BRITISH COLUMBIA TIMBER SALES, CHINOOK BUSINESS AREA

PHASE 3 REVIEW OF TSL A94817
BLOCKS G043B4SG & G043C3ZP
ROBERTS CREEK AND STEPHENS CREEK WATERSHEDS

Polar File: 740202
BCTS Contract: 10005-40/PD21TBF001
FINAL REPORT
DECEMBER 2023

Re: Phase 3 Review of TSL A94817 in Roberts Creek and Stephens Creek Watersheds

FIGURE 1.2 Harvest plan map for TSL A94817, blocks G043B4SG and G043C3ZP (as of August 2, 2022) that was subject to field review. Map source: BCTS.

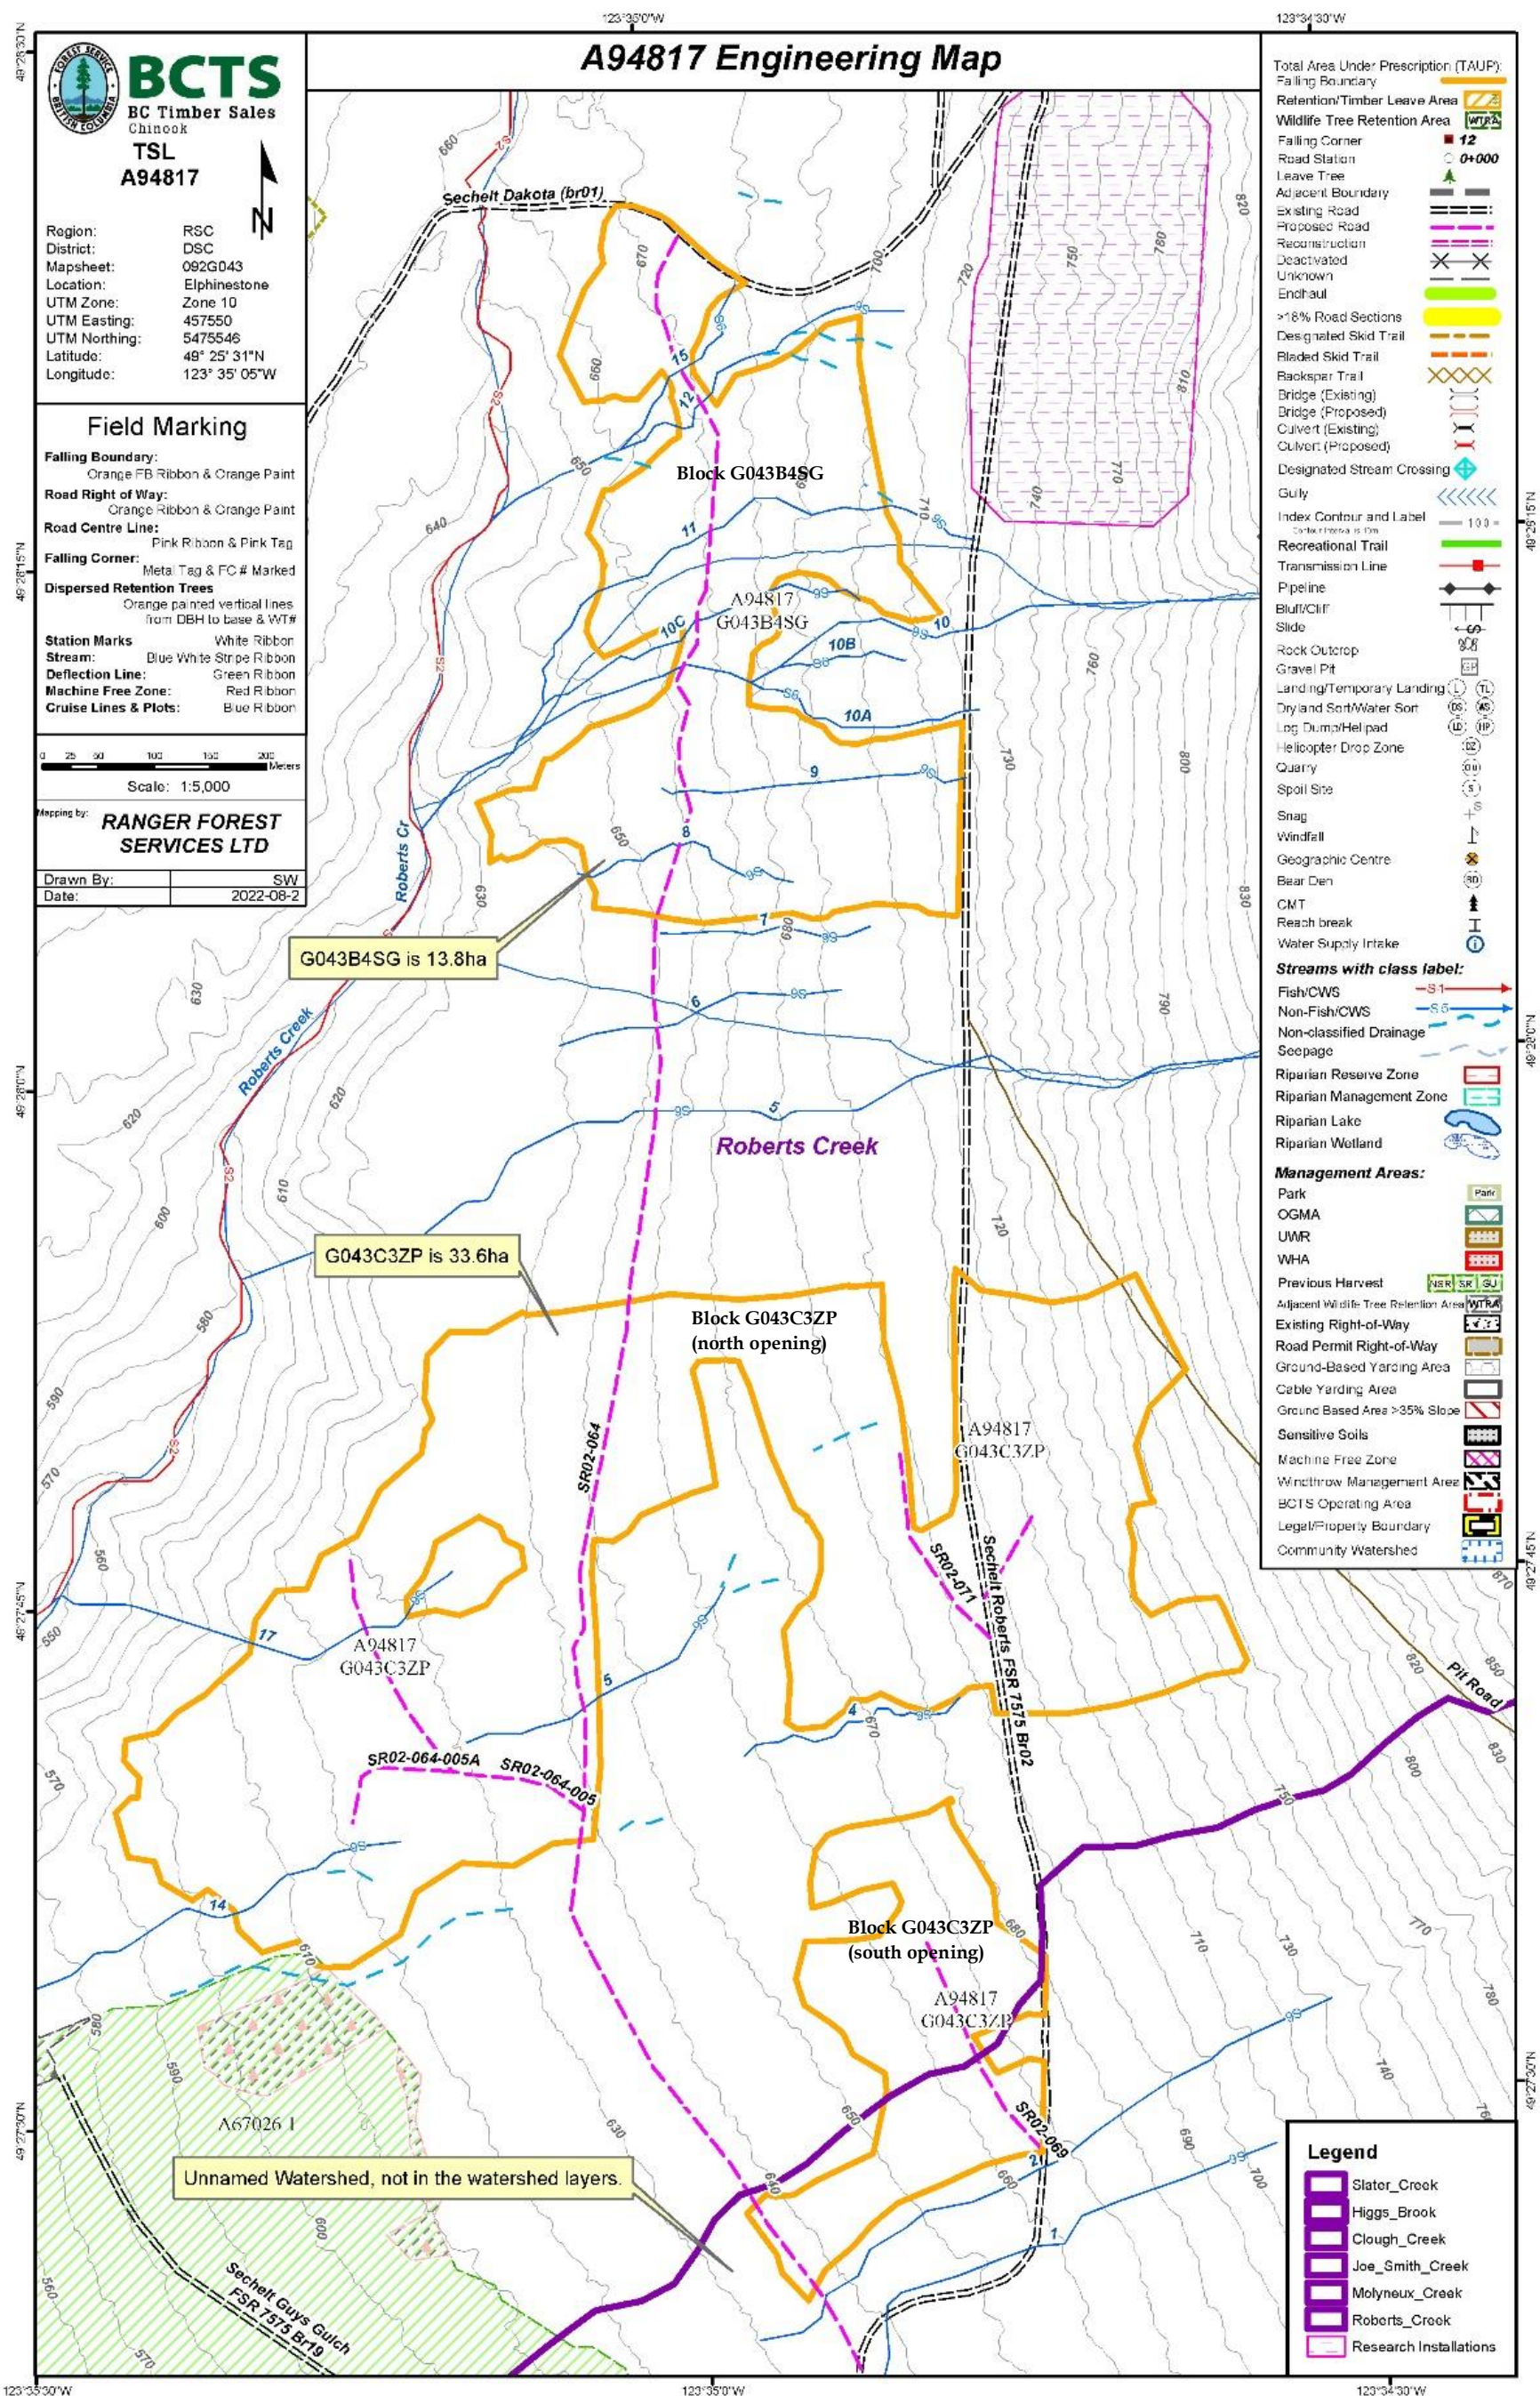
Our main observations from the field review are provided below, organized by block and opening. The comments are referenced to the site plan dated August 2, 2022 (FIGURE 1.2).

- An S6 stream (labeled "14" on FIGURE 1.2) emerges as a spring in the southwestern portion of the opening. Although dry on the date of the review, the channel is up to 2.0 m wide, partly incised with cobble and gravel bed and laterally stable. Abundant wood was noted along the channel including several cut pieces (FIGURE 3.6).

- An S6 stream (labeled "17" on FIGURE 1.2), flows along a wide gully and was either dry or had some wet areas but not flowing water. The channel has a boulder and cobble bed and appears stable, although minor incision was noted near the block boundary.

- This block has a higher drainage density within block relative to the others within TSL A94817; most are S6 streams and NCDs, however one stream (labelled “10A” on FIGURE 1.2) is notably active (i.e., downcutting and laterally shifting) and has a channel width near the upper end of S6 streams (i.e., 3 m), and occasionally exceeding 3 m (although only locally).

- A narrow riparian buffer (5 m +/-) is noted along portions of stream 10A. This may pose a windthrow and sediment hazard to the stream. Conveyance of potential sediment to Roberts Creek from stream 10A following possible windthrow is likely.

With reference to the conservation of summer low flows, the blocks on the August 2, 2022 plans exceed the recommendation presented in Polar (2023) to limit net opening sizes⁹ to less than 8 ha for each planned block. To meet this recommendation, BCTS would need to either 1) reduce the overall planned block areas or 2) split the planned blocks into several smaller openings, such that adjacent openings are sufficiently buffered from wind and solar radiation.

1. Establish machine free zones (MFZs) 5 m wide on each side of S6 streams within the blocks and minimize, where practical, crossings of S6 streams by heavy equipment.
2. NCDs are common in the blocks and are usually associated with topographic lows, shallow gullies, moist soils and hydrophytic vegetation (Devil’s Club, ferns, mosses, etc.). Excessive soil disturbance of NCDs followed by high runoff can result in erosion, downslope sedimentation, and in some cases conversion of NCDs to S6 channels. In effect, groundwater

3. Stream "10A" in block G043B4SG is an active S6 channel with evidence of downcutting and lateral shifting, partly in response to windthrow along the riparian zone. Currently, the block boundary west of the planned road crossing of SR02-064 is less than 5 m from the channel. To minimize the risk of windthrow and channel disturbance, we recommend widening the buffer to a minimum of 15 m or wider if determined through a windthrow assessment.

FIGURE 1.3 Harvest plan map for TSL A94817, block G043B4SG (as of December 7, 2023). Map source: BCTS.

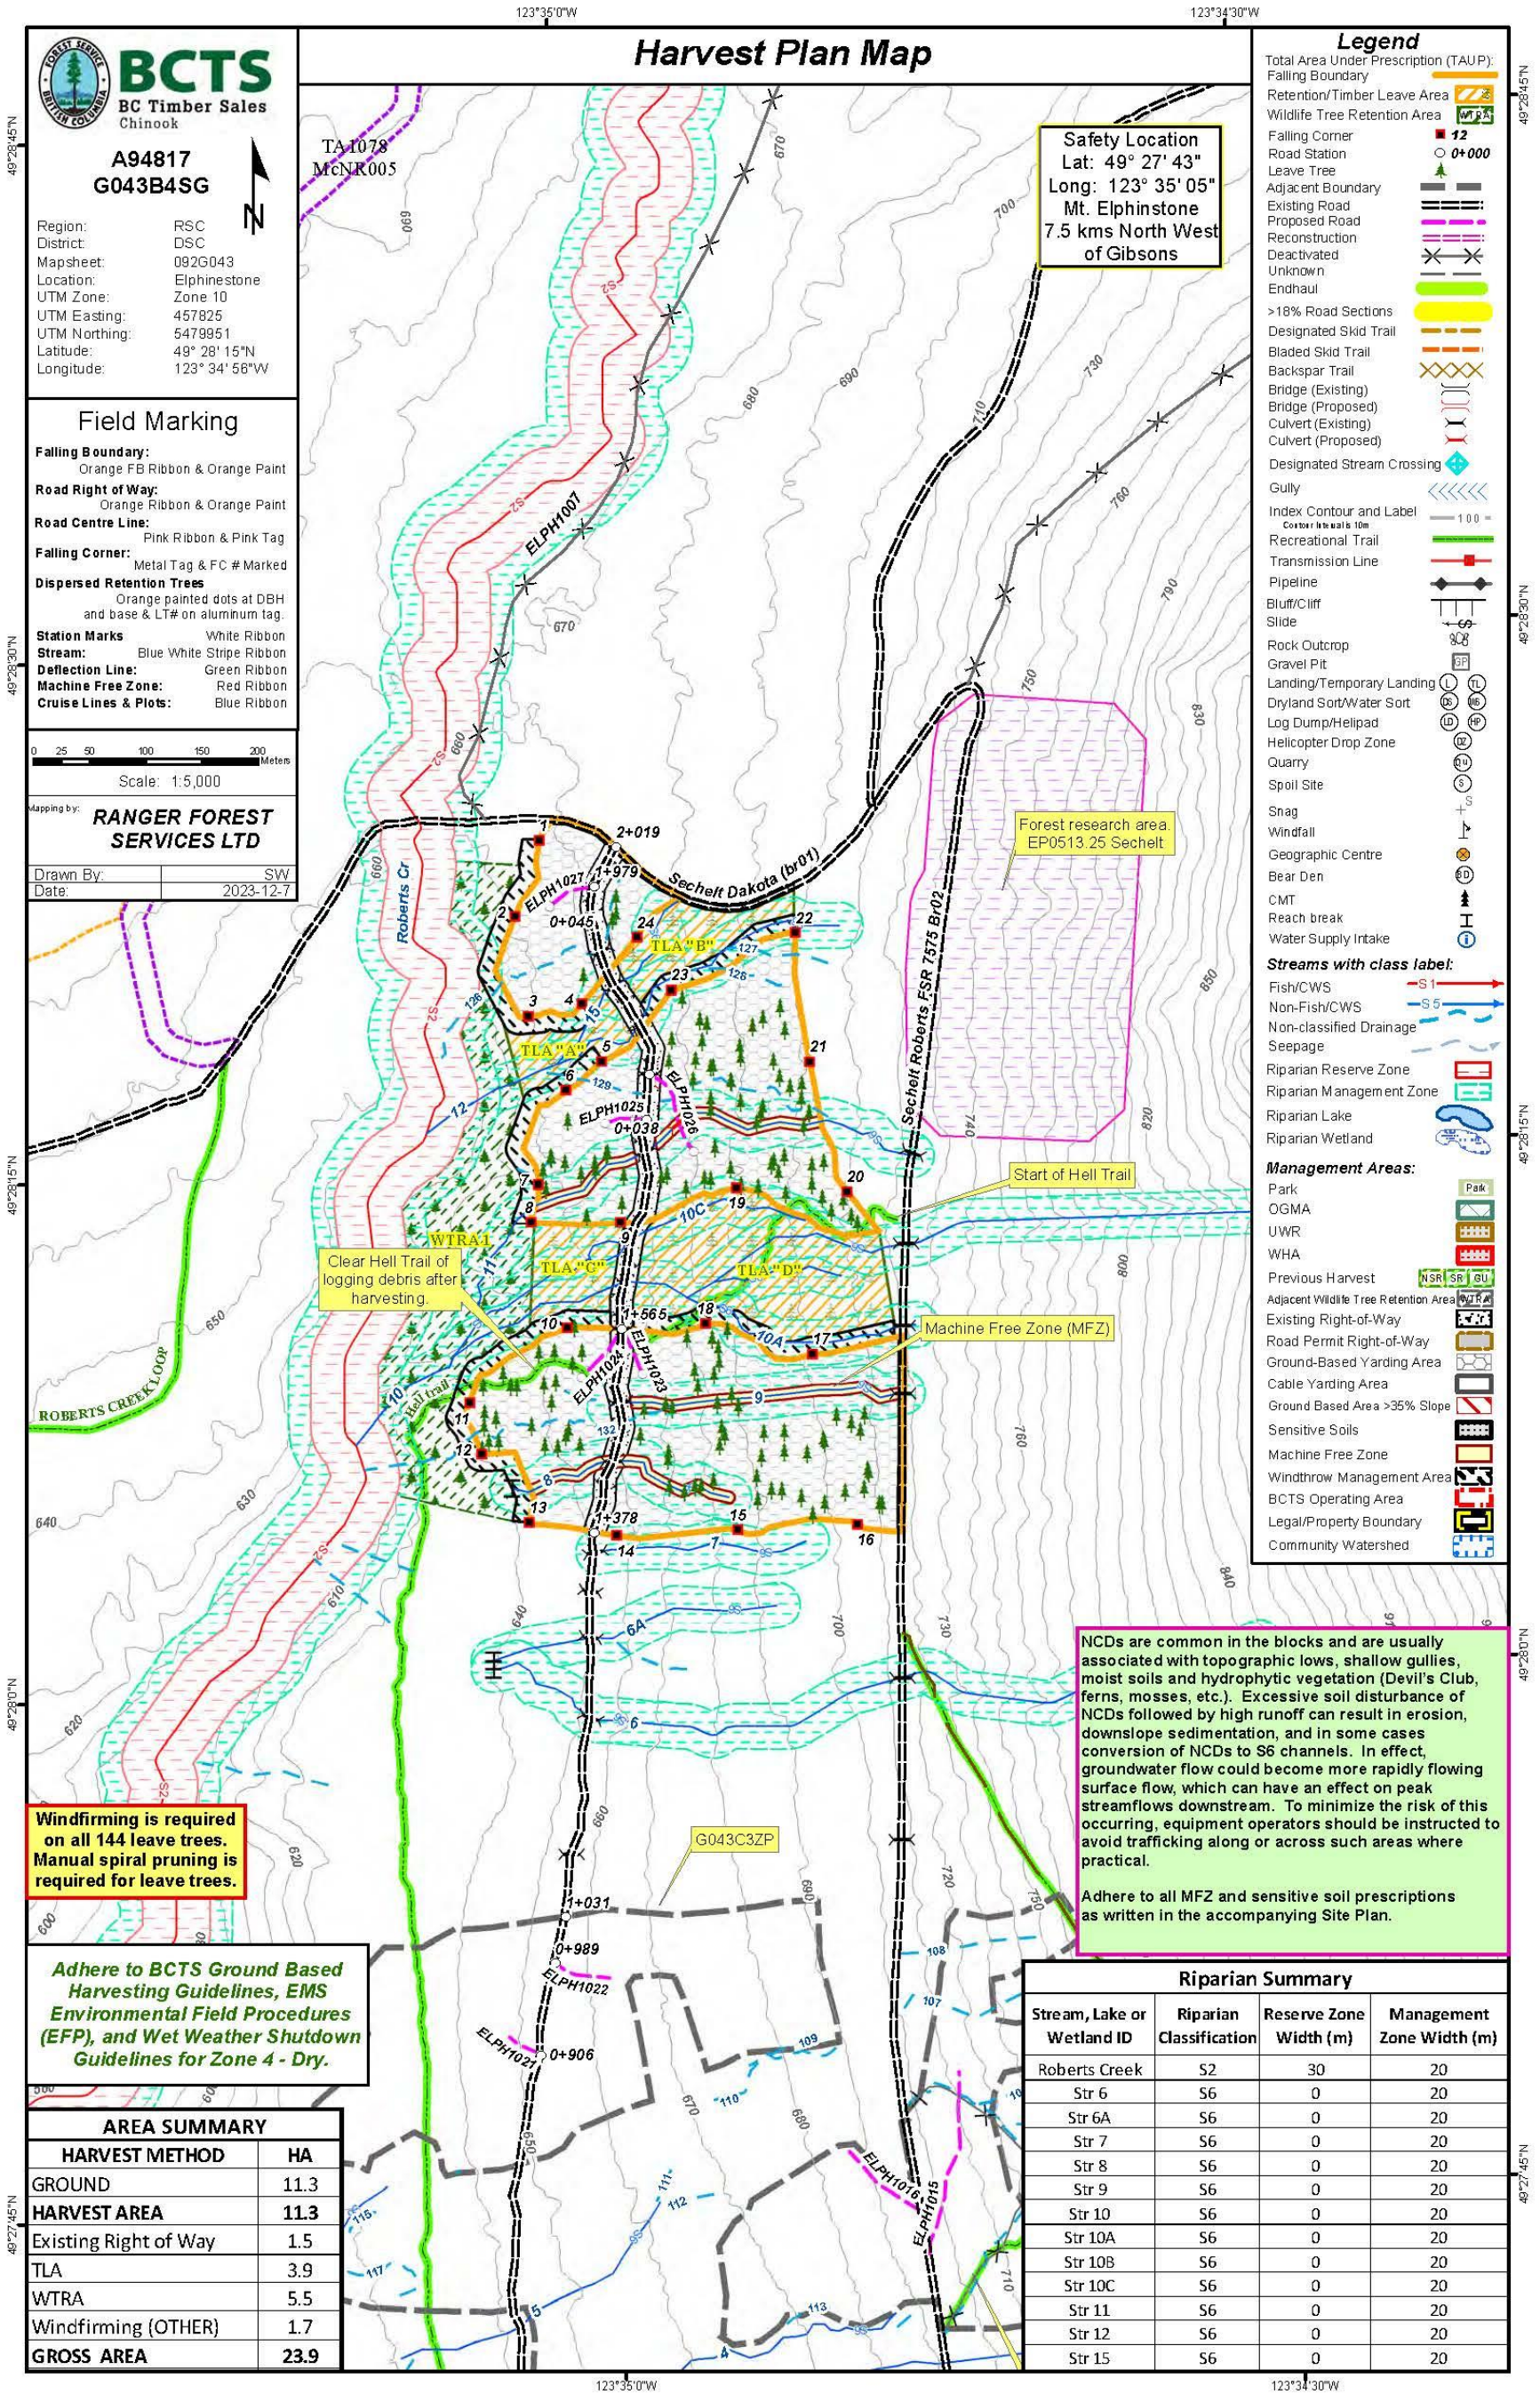
In response to our recommendations on the August 2022 site plan (noted in Section 4.0), BCTS further refined its plans to better align with the Phase 1 and 2 recommendations outlined in Polar (2023). The following summarizes these changes presented on FIGURES 1.3 and 1.4.

For the conservation of summer low flows, Polar (2023) recommends limiting net opening sizes in each block to less than 8 ha. The December 2023 harvest plans include three openings of planned block G043B4SG ranging from 1.62 ha to 6.11 ha, and four openings for planned block G043C3ZP ranging from 4.52 ha to 7.56 ha. Each opening has also been separated by a minimum distance of 2 tree heights in order to buffer each opening from wind and solar radiation. Further, 144 leave trees have been field marked and flagged in each block, which will be subject to windfirming.

Substantial revisions have been made in the December 2023 harvest plan to further protect riparian function along classified streams. Such protection includes the removal of substantial portions of block G043B4SG to exclude the riparian zone of streams 10¹⁵, 12 and 15¹⁶ (FIGURE 1.3), establishing machine free zones (MFZs) a minimum of 5 m on either side of other S6 streams, and emphasizing on the harvest plan map the need to avoid machine trafficking on non-classified drainages (NCDs) and maintaining advanced regen or mature timber in MFZs where practicable. Further, to reduce the likelihood of windthrow, a windthrow assessment will be conducted along opening edges and wind firming treatment will be completed as required (Aubin, pers. comm., 2023).

A terrain stability assessment (TSA) has been conducted for both of the planned blocks (Onsite Engineering Ltd., 2023). Recommendation included the removal a small area from the south-western corner of planned block G043B4SG, which has been addressed in the December 2023 harvest plan map, and wind firming as reflected on the December 2023 harvest plan maps.
